SERVICETEKNOTES

TABLE OF CONTENTS

Figure 1.
Composition and Film, respectively.

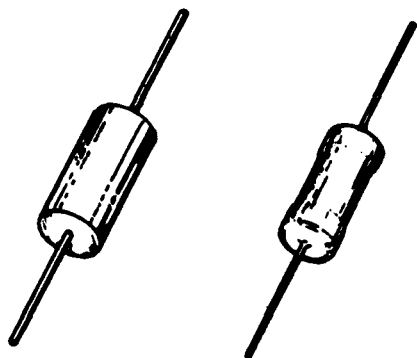
Various resistors in the 606(A), 606B and 608 are exhibiting a high failure rate. They are as follows:

Product	Circuit No.	Part Number
606(A)	R770	301-0181-00
606B	R162	301-0391-00
608	R858	301-0470-00
	R879	301-0151-00
	R880	301-0221-00

To correct this, only the carbon composition versions of the above part numbers should be used for these applications. Use of carbon film or metal film versions of these parts should be avoided. The distinction between composition and film parts is easily seen in the illustration below.

Prior to 1980, all 301-XXXX-00 and 302-XXXX-00 were carbon composition. During 1980/81, a projected shortage of composition parts required the purchase of carbon film and metal film resistors to maintain production. As a result, inventories of 301- and 302- components became mixed with both film and composition parts.

In high voltage applications, the film components have shown some distinct disadvantages. Metal film parts tend to open up without giving any visible evidence of their failure. Carbon film parts may drift in value due to migration of conductive particles (the Lorenzo effect). It is therefore advisable to avoid film resistors in any high voltage application.

Figure 1. CR566 Added.

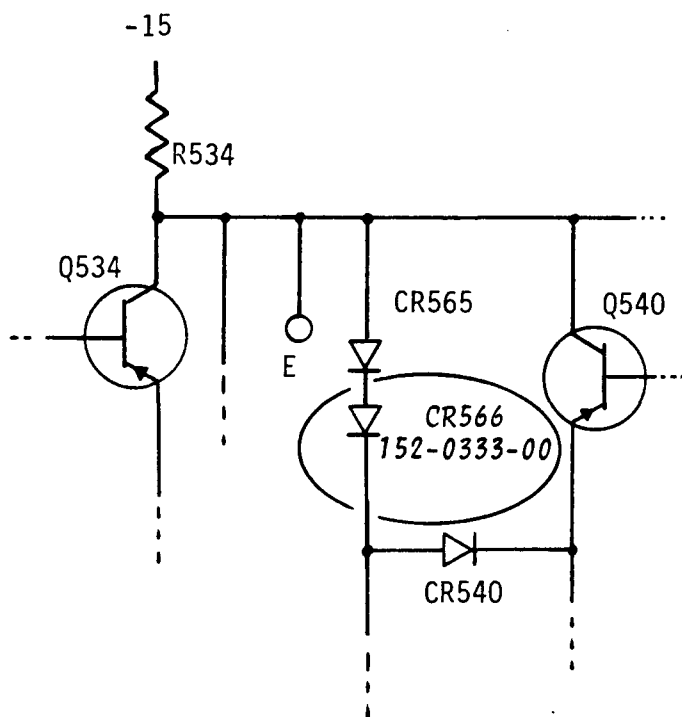
The 608 CRT specifications exceed the range of the Z-axis amplifier. As a result, setting cutoff on the 608 may not be possible with some CRTs.

To correct for this problem, a diode is added in series with CR565 in the Z-axis amplifier. The new diode, CR566, is part number 152-0333-00 and is mounted in tee-pee fashion. The part number of the Z-axis amplifier board rolls from 670-5216-02 to 670-5216-04 with this change.

Printer Mechanism Assembly

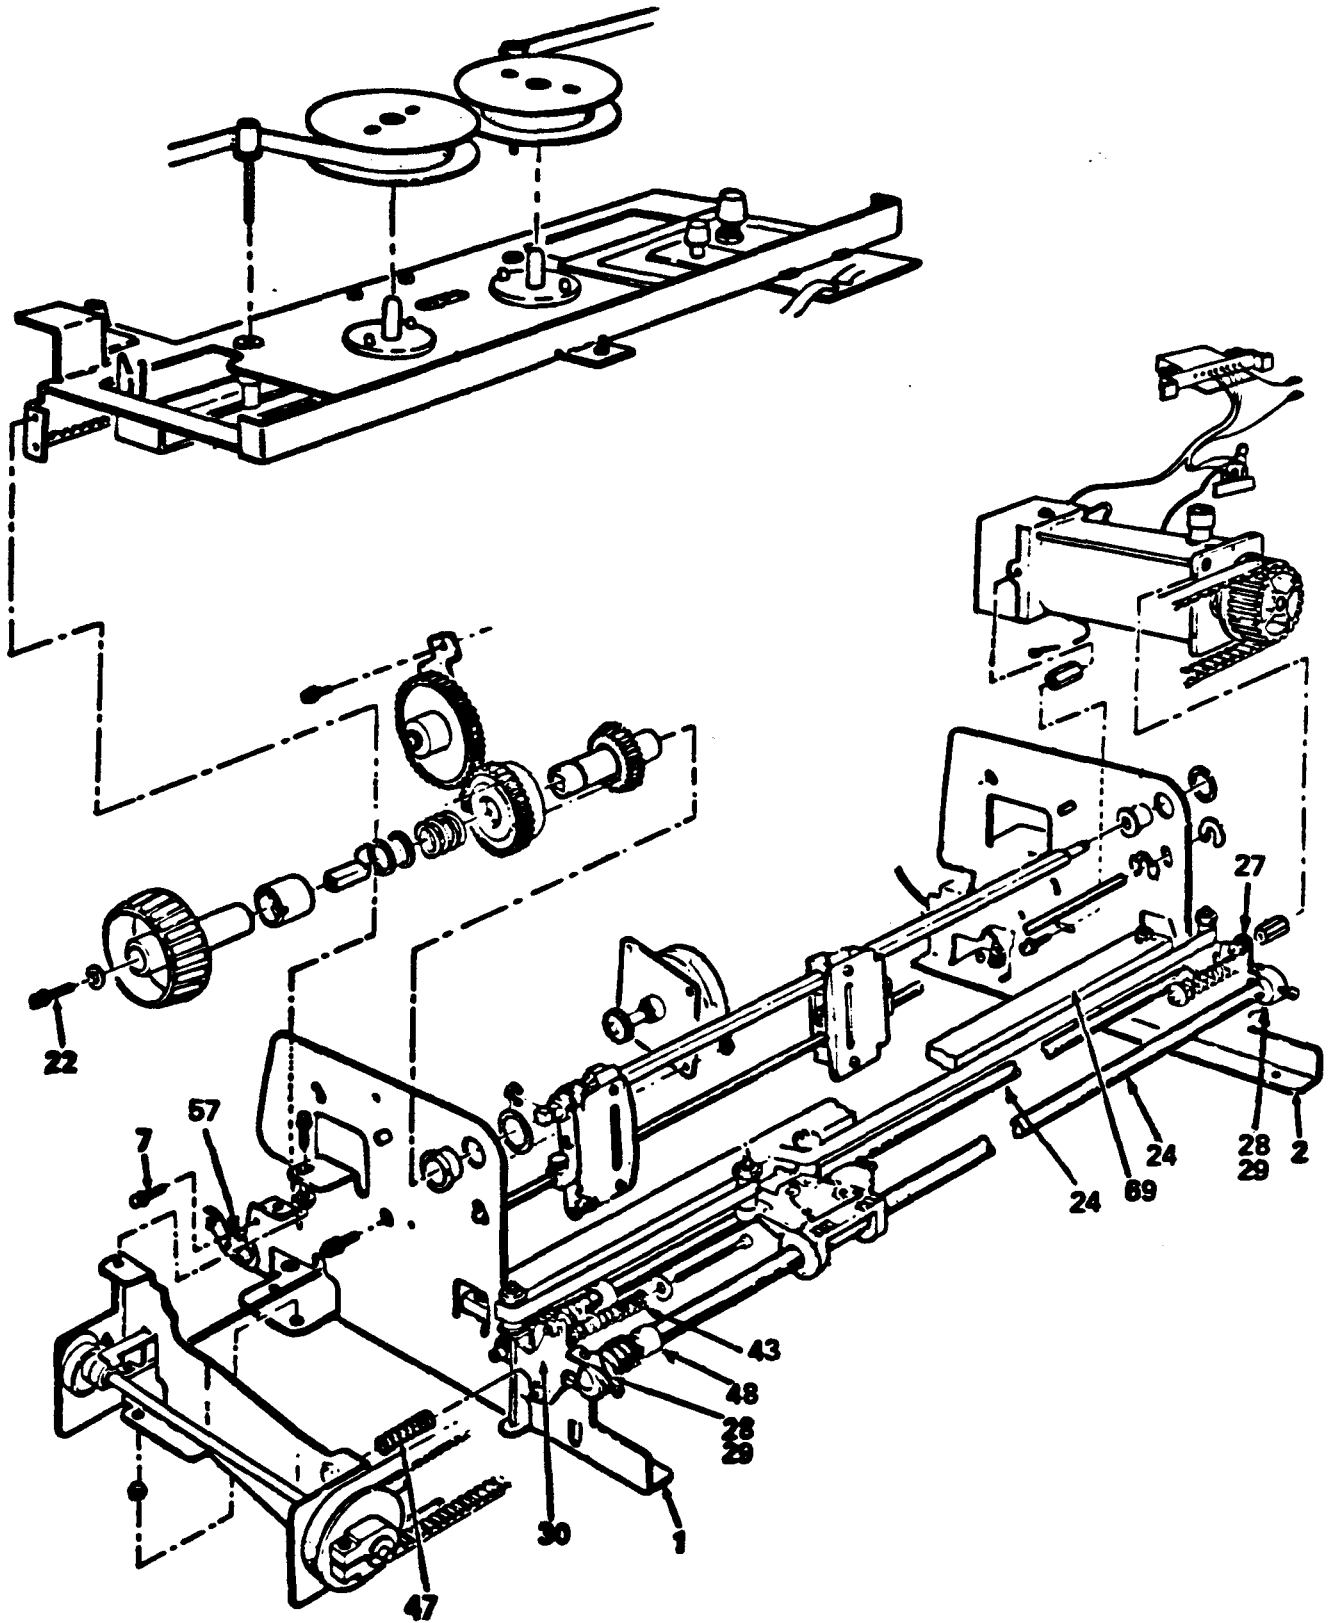
The 4641/4641-1/LP8200 is an OEM product that Tektronix purchases from Digital Equipment Corporation (LA-180). Until it was brought to our attention, we were unaware that DEC had modified the printer mechanism assembly. Furthermore, we are not able to establish a serial number break for the printer mechanism modification, because DEC has been shipping to Tektronix from a mixed stock of old and new version printers. The following drawing and parts list should be used in conjunction with the service manual when servicing the newer version printer.

The parts list only covers the parts that were affected by DEC's modification. Refer to the service manual to find part numbers for parts that were not changed. The parts affected by the change are not interchangeable between older and newer version printers. It is not recommended that these parts be purchased for local stock, they should only be ordered on an as needed basis.

<u>Index*</u>	<u>DEC Part Number</u>	<u>Tek Part Number</u>	<u>Description</u>
28	74-18137-00	118-3416-00	Clamp, Shaft 4641
29	90-06037-01	118-3417-00	Screw, Phil Pan HD #8-32x.38
30	74-18138-01	-----	Retainer, Shaft 4641
43	74-11816-00	118-3419-00	Spring, Carriage Bumper 4641
47	90-09578-00	-----	Spring, Compression 4641
48	74-13672-00	118-3421-00	Reservoir, Oil 4641
1	74-18142-00	118-3422-00	Plate Side, Left Hand
2	74-18142-01	118-3423-00	Plate Side, Right Hand
7,57	90-09988-01	-----	Screw, Sems Hex HD #6-32x.56 Cone
22	90-09984-00	-----	Screw, Sems Phil HD #6-32x.38 Cone
24	74-18139-00	118-0087-01	Shaft, Carriage 4641
27	74-18138-00	-----	Retainer, 4641 Shaft
--	49-01174-00	-----	Oil, 4641
69	74-17937-00	118-3428-00	Bar, Print, Assembly

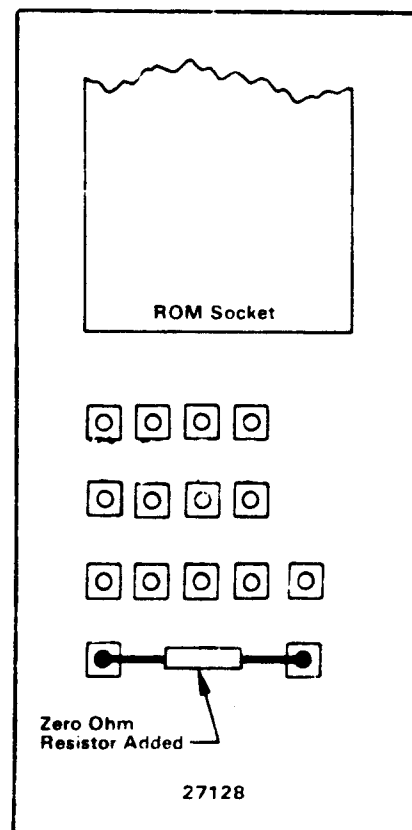
A wire strap or zero ohm resistor must be added to each chip location of the System ROM board before they will accept the 27128 devices. The strap should be added as shown in the following illustration:

NOTE: This strap enables address line 13 to pin 26 of the corresponding ROM socket. Pin 26 of a 2764 EPROM is not connected internally; therefore a socket that has been modified to accept 27128 EPROMs will work fine with a 2764. New System ROM boards shipped from Manufacturing and Board Exchange have zero ohm resistors installed for all ROM locations.
